CITY OF ALBUQUERQUE

PLANNING DEPARTMENT – Development Review Services

**Re: La Luz del Oeste, Unit 4 Grading and Drainage Plan
Grading and Drainage Plan
Engineer's Stamp Date 9-2-2014 (File: F11D002A)**

GRADING AND DRAINAGE

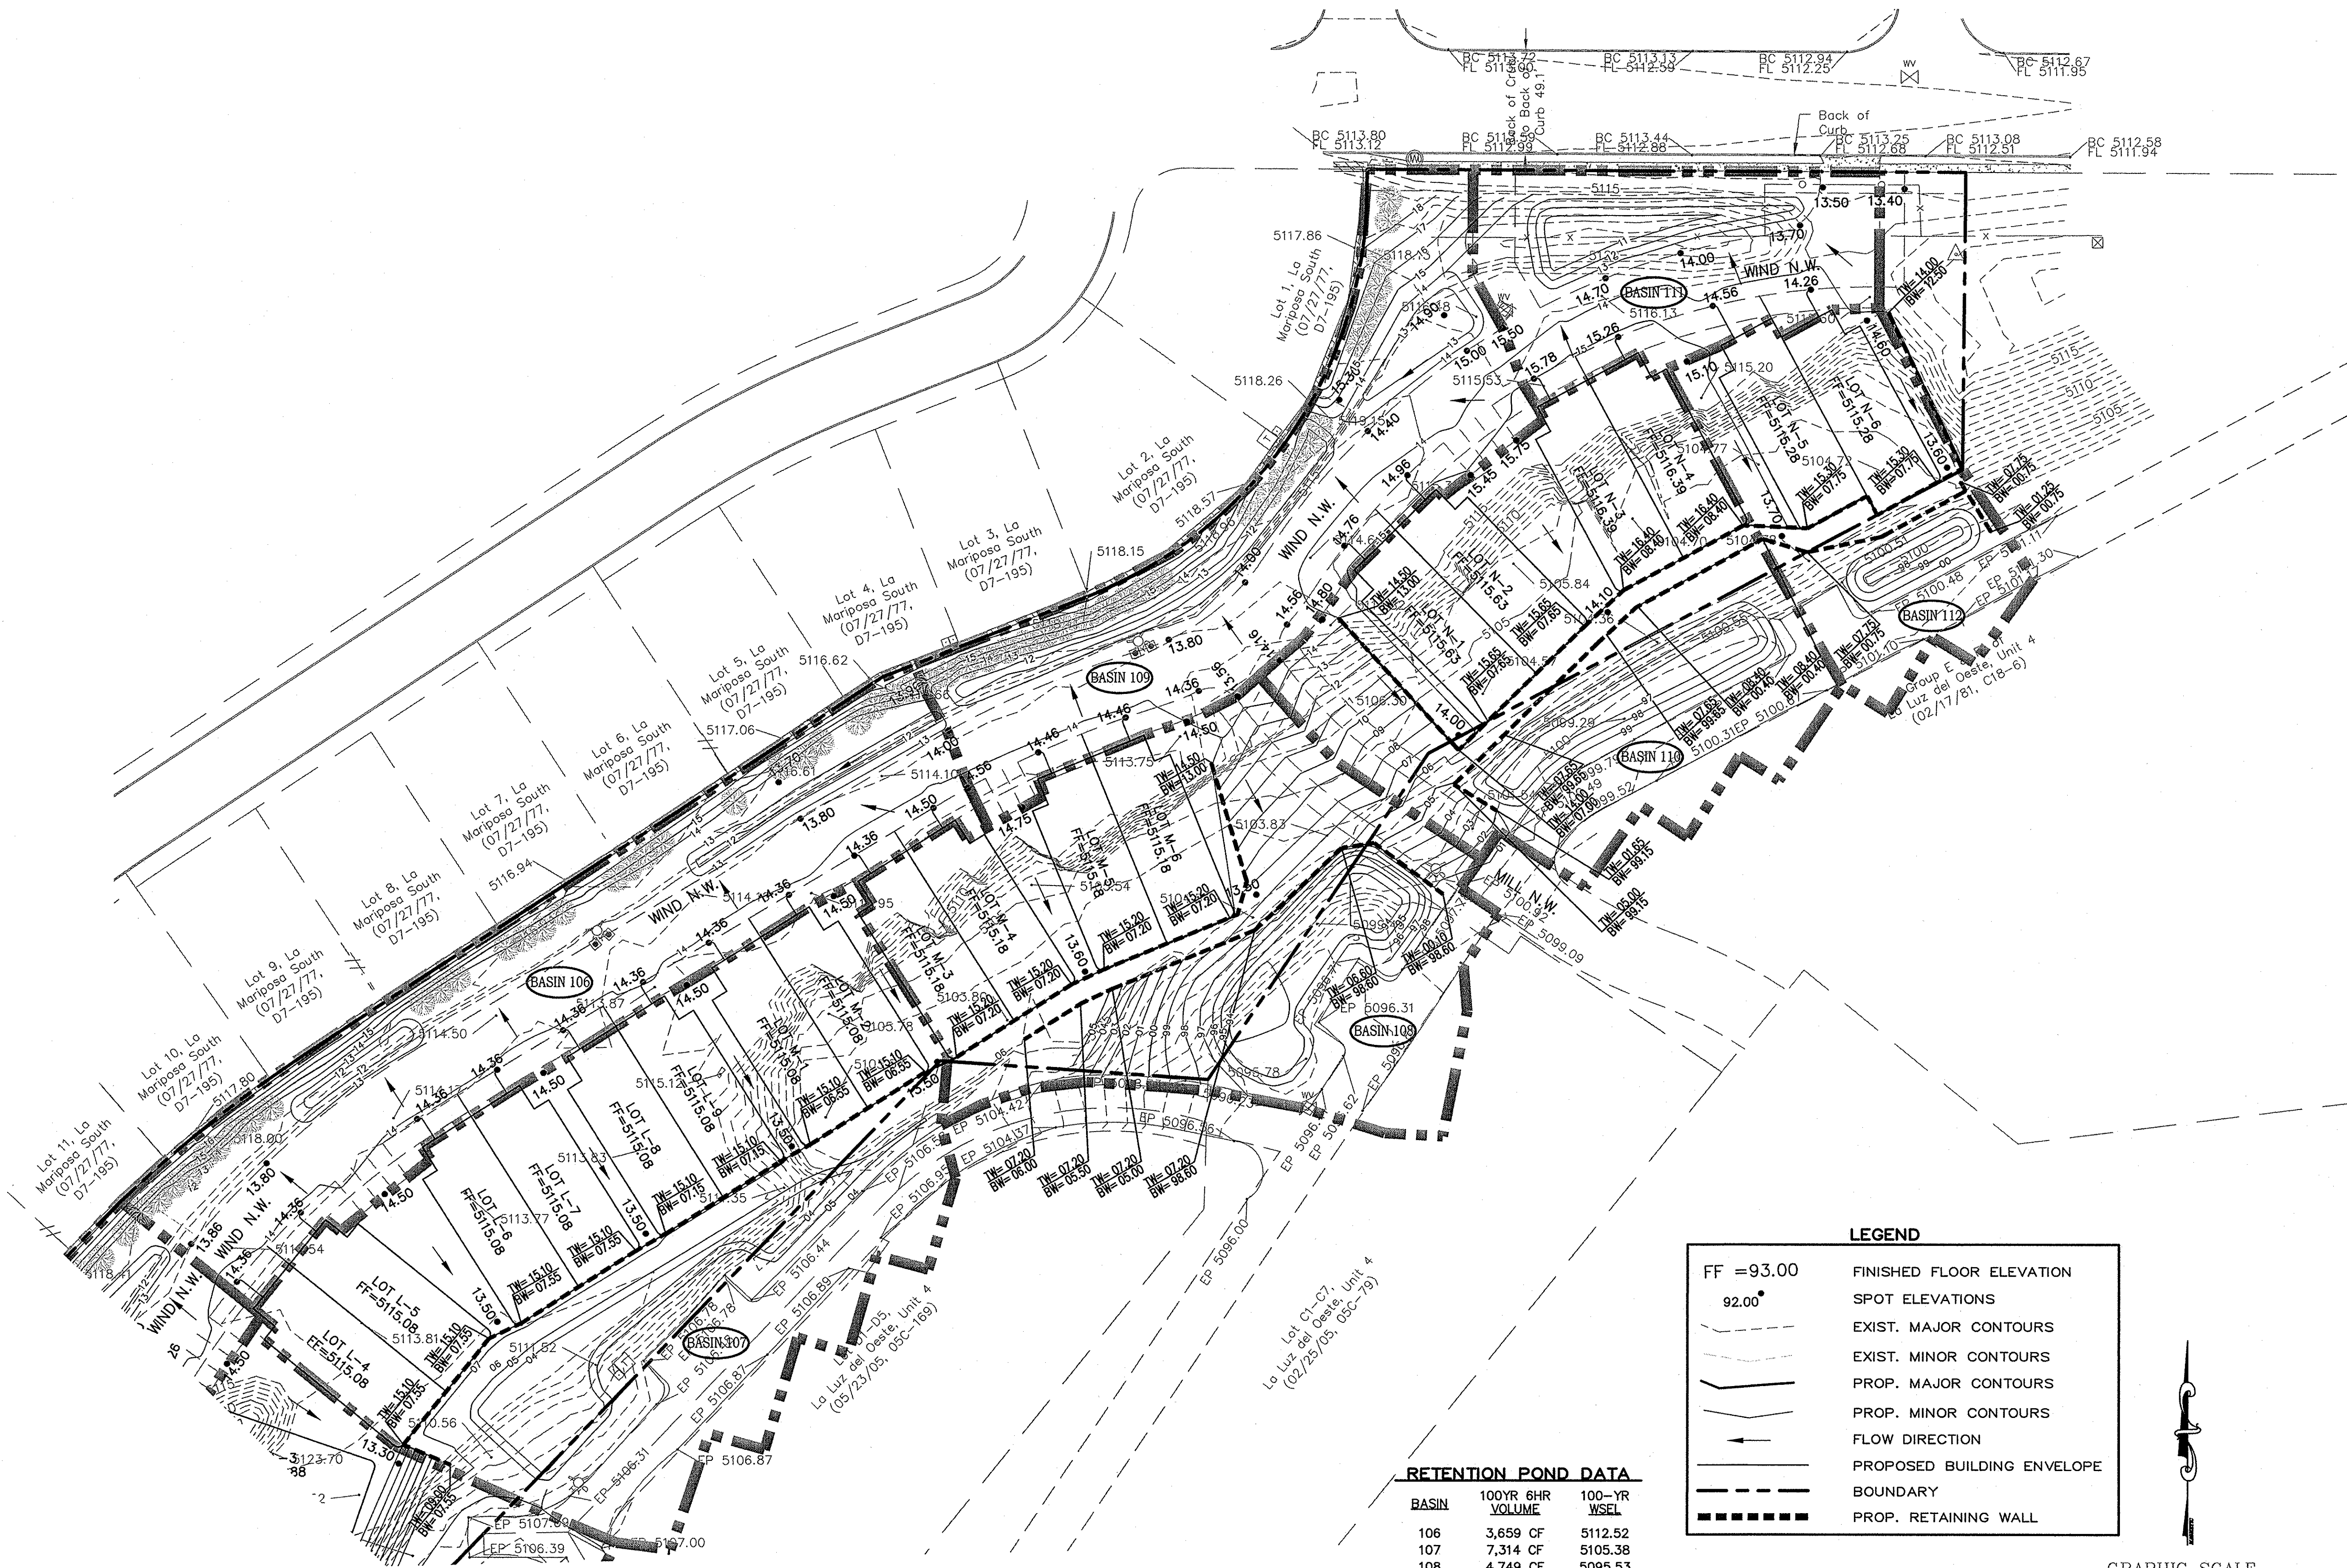
- Ponds in Basin 101 and 106 must maintain a percolation rate of 2.9 min/in. Pond volumes in these basins are considerably smaller than in the previously approved submittal. However, it is noted in the narrative that only the roadway drains to those ponds and a percolation rate of 2.9 min/in is used for the soils. The ponds only seem to be sufficient if the percolation rate is factored in. Therefore, provide percolation test data and note the percolation rate on the As-built Certification Plan.
- The Pad Elevations are higher than the previously approved submittal
- Distance between double retaining walls changed to 10' (not shown on section detail)
